CONVAIR

COMMERCIAL CHANGE PROPOSAL

SPEC NO.: ZD- 22-003

CUSTOMER: Delta Air Lines Inc.

Enclosure: (A) One copy of sketch - GASEOUS OXYGEN SYSTEM
(for preliminary use only, Figure 3.19-4 will
be revised to reflect the above change)

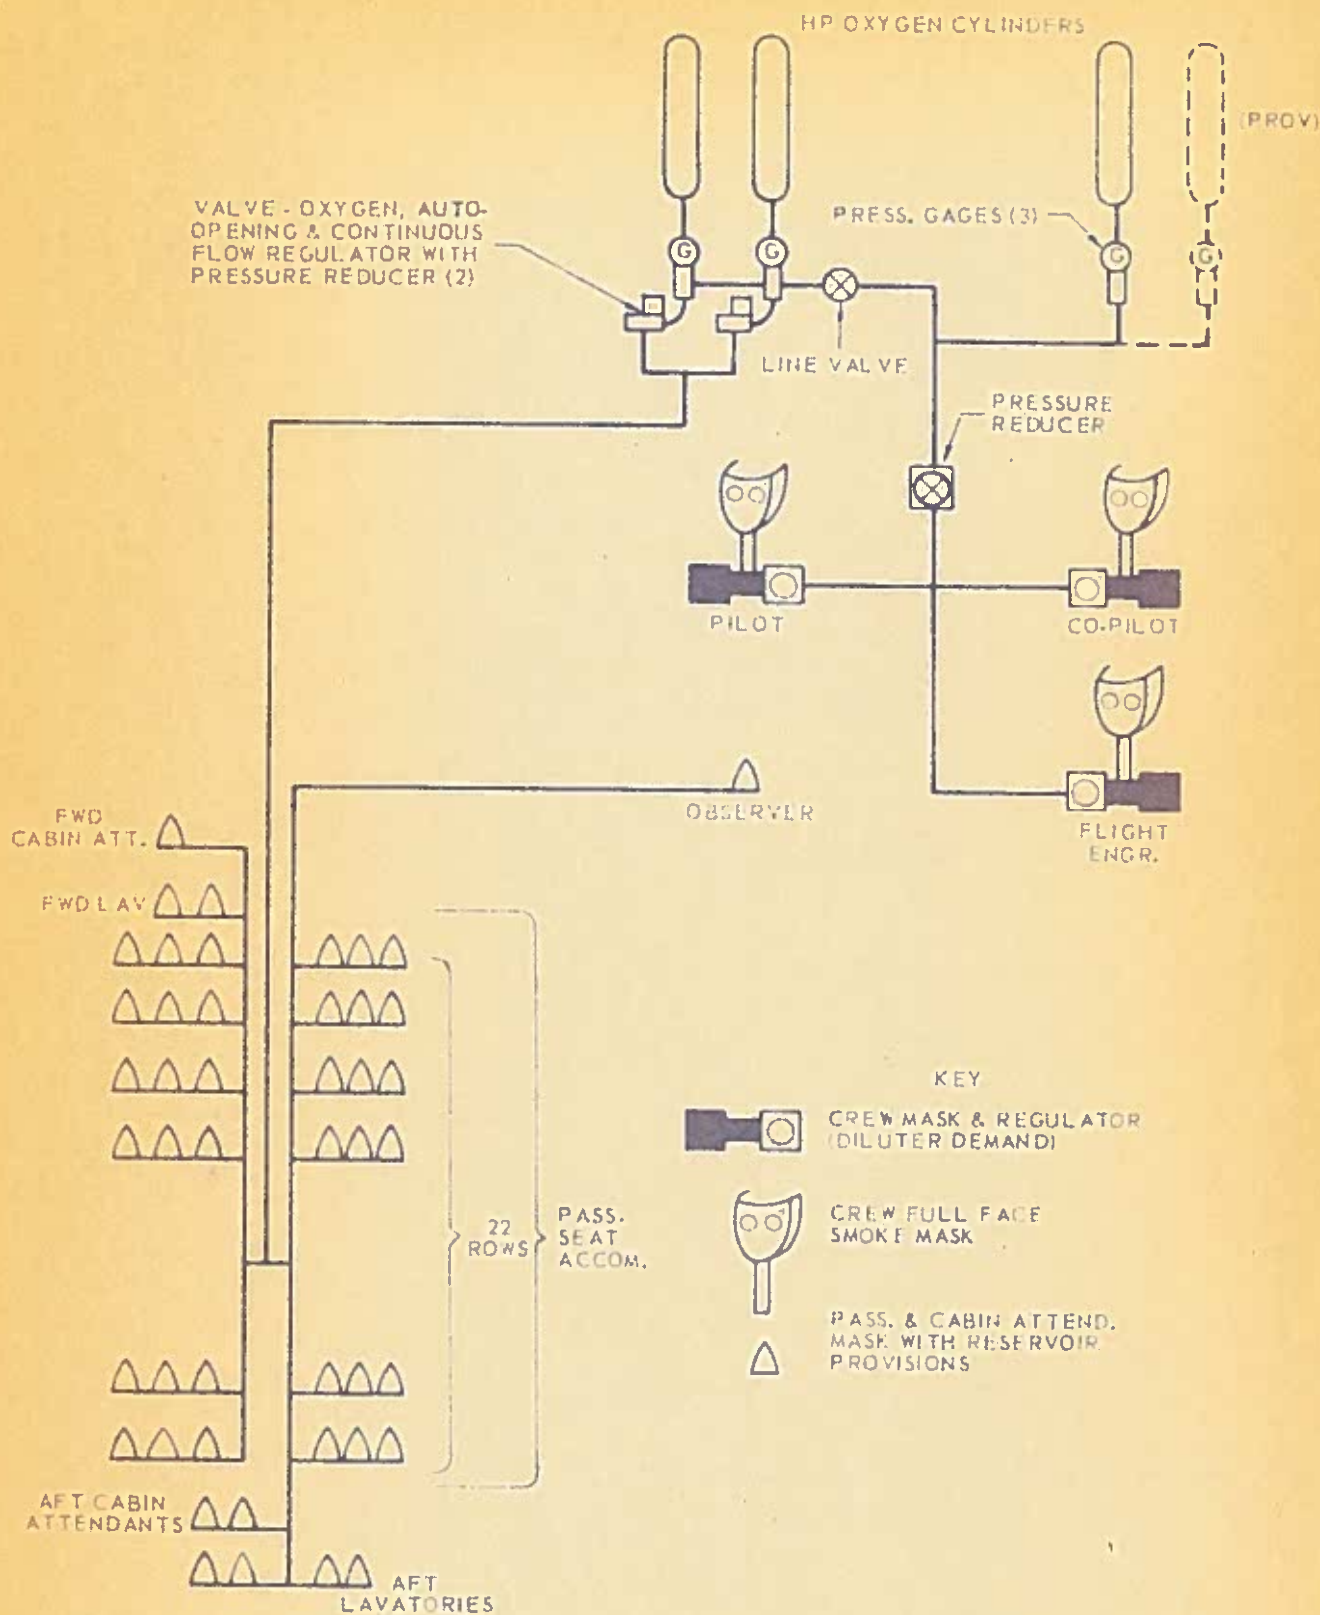
Page 114, Paragraph 3.19.5.5 MASKS:

Delete the following sentence from the paragraph:

"One oxygen outlet shall be provided in each lavatory."

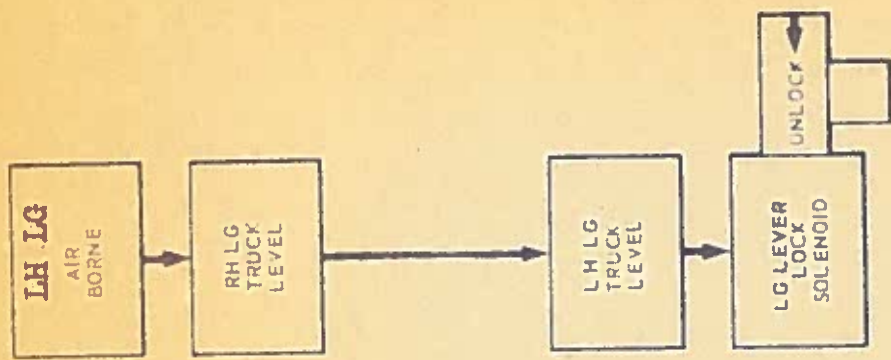
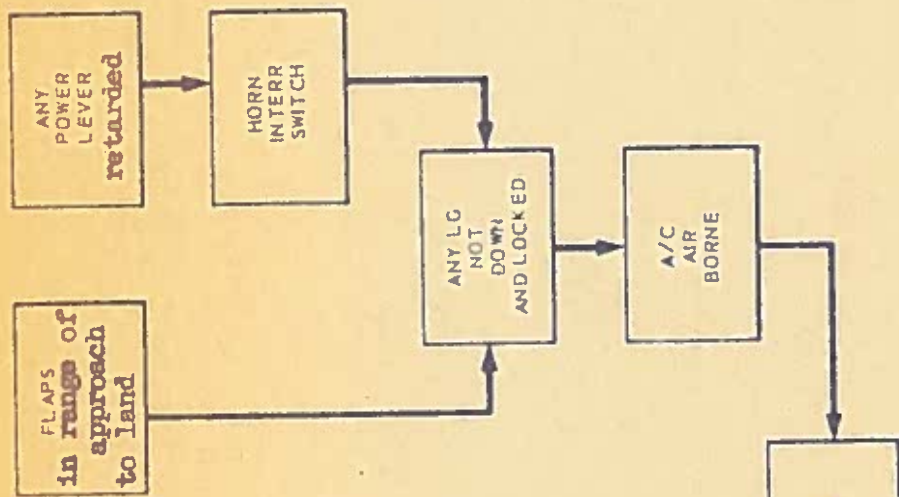
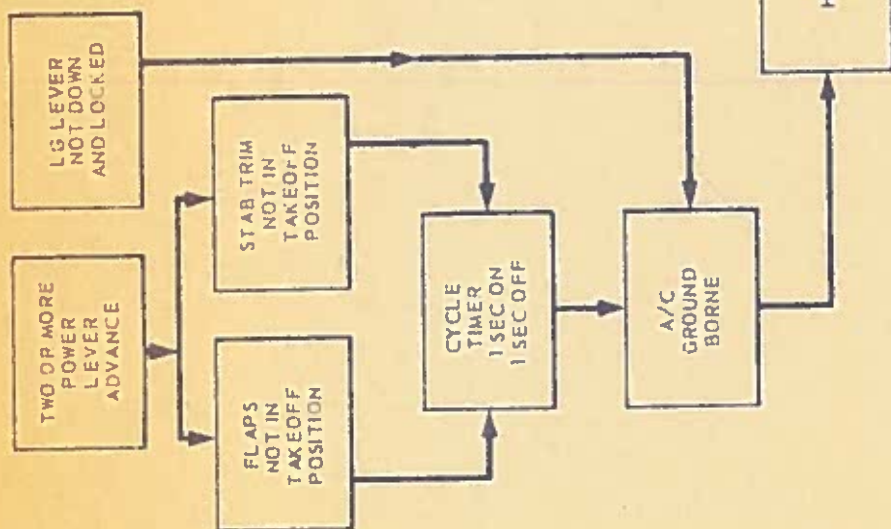
Revise the paragraph title and paragraph to read as follows:

"LANDING GEAR AND STABILIZER WARNING HORN: A horn shall be provided
to operate under the following conditions:

When any landing gear is not fully extended and locked with the air-
craft airborne, the horn will operate if any power lever is retarded
or if the flaps are in the range of approach to land. The power lever
retard function will have a horn interrupter switch.

When the aircraft is ground borne, the horn will operate if the landing
gear override lever is moved.

When the airplane is on the ground and any two or more of the power
levers are advanced to take-off position, the horn will operate if
the stabilizer and/or the flaps are not in the correct take-off posi-
tion."
